# Access Compliance Report

## Public Rights-of-Way

### (Curb Ramps)

Intersection ID: 23447	Main Street: BRACKENBURY_LN	Cross Street: ALEXANDER_RD	Location: W
ADA ID: CDD2F6C546AE	Ramp Type: Perp	Initial Pass/Fail: Fail	Overall Compliance: No
Severity Score: 21.25			
Codes/Mitigation Info/Possible Solution		Field Measurements/Component Compliance

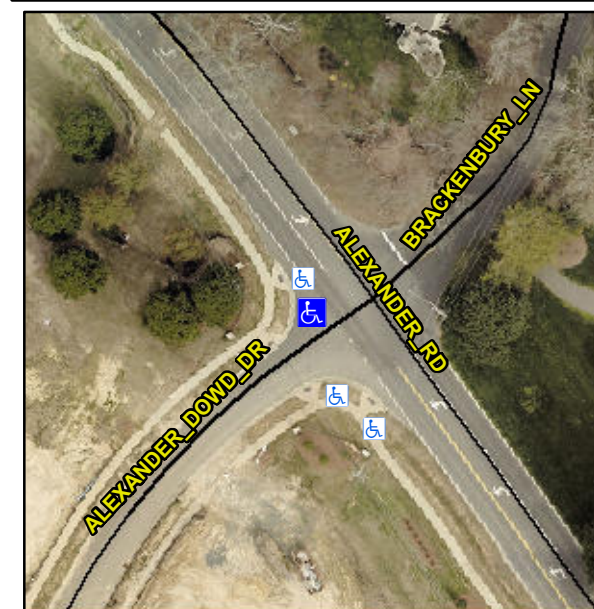
**R304.5.1, R304.2.2**

Compliance	Description	Data	Compliance	Description	Data
N/A	Ramp Length (in)	96.0	No	Ramp Slope (%)	8.6
No	Ramp Width (in)	47.5	Yes	Ramp XSlope (%)	1.6
N/A	Flare Type LT	N/A	N/A	Flare Type RT	N/A
N/A	Flare Slope LT (%)	N/A	N/A	Flare Slope RT (%)	N/A
N/A	Flare Traversable LT?	N/A	N/A	Flare Traversable RT?	N/A
N/A	Landing Length (in)	N/A	N/A	DWS Provided?	N/A
N/A	Landing Width (in)	N/A	N/A	DWS Contrast?	N/A
N/A	Landing Slope (%)	N/A	N/A	DWS Length (in)	N/A
N/A	Landing X Slope (%)	N/A	N/A	DWS Full Width?	N/A
N/A	Landing Curb? (Y/N)	N/A	N/A	DWS Offset (in)	N/A
N/A	Shared Landing?	N/A			
N/A	Gutter Ponding?	N/A	N/A	Gutter Slope (%)	N/A
N/A	Gutter Lip Ht (in)	N/A	N/A	Gutter X Slope (%)	N/A
N/A	Painted X Walk1?	No	N/A	Painted X Walk2?	N/A
	X Walk 1 Direction	To S		X Walk 2 Direction	N/A
N/A	X Walk 1 Width (in)	N/A	N/A	X Walk 2 Width (in)	N/A
	X Walk 1 Slope (%)	2.6		X Walk 2 Slope (%)	N/A
	X Walk 1 X Slope (%)	4.9		X Walk 2 X Slope (%)	N/A

**Remove & Replace Entire Ramp.**
